## Briefing session questions for the following tender

### TA135-RFP/TVO/2020/30-HENLEY NEWS BRANDING AND GRAPHICS

#### Questions & Answers

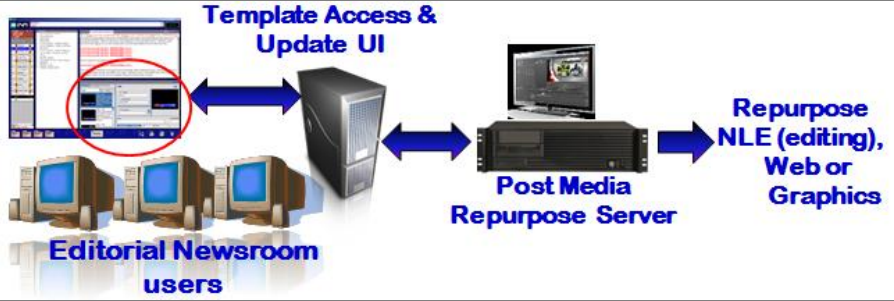
Allow the Newsroom to be displayed in a simplistic rundown format; Newsroom scripts and rundown activation NRCS/NPS list of predefined stories that allow stories to be played as they would in the bulletin  
**Once driven by NRCS, Graphics rundown would be created accordingly. Is that what is required here?**

No this is not the graphics interface or graphics related but the actual operations Newsroom UI Running Order as seen on the NRS workstations.
